EN010127- Application by Mallard Pass Solar Farm Limited for an Order Granting Development Consent for Mallard Pass Solar Project

ISH 1, Scope of the Proposed Development, Need, Site Selection and Alternatives

Submission by John Hughes ref ID. 20036141

Written Response to oral submission.

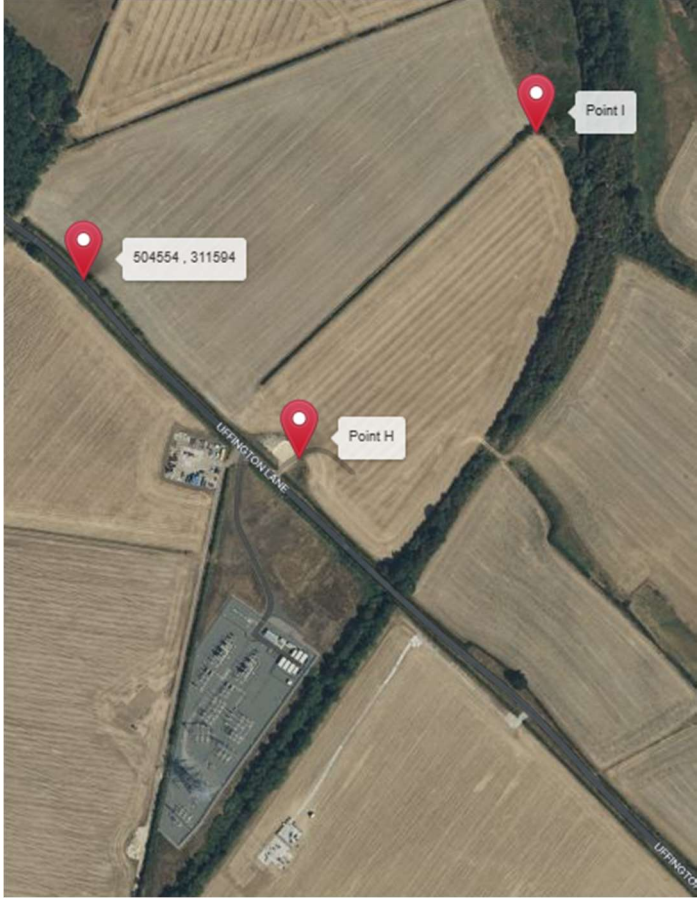
The visual impact of the substation does not have to represent that of other substation presented and could but excavated down into the land so the tallest structures are no higher than current ground level at the lowest point of the proposed site location so mitigating the visual impact on the horizon. Field 19 has approximately a 10m elevation change between the top of the field point (H) (were the current hard core is) and the bottom of the field closest the railway point (I)

The Applicant has, or will have, the ability to procure the necessary land and rights in order to provide the proposed Onsite Substation to facilitate the Grid Connection, does the result of this mean the substation will not be decommissioned and the land in field 19 would not be put back to agricultural use and in future could be used for justification of granting future developments to the West of the East Coast Mainline?
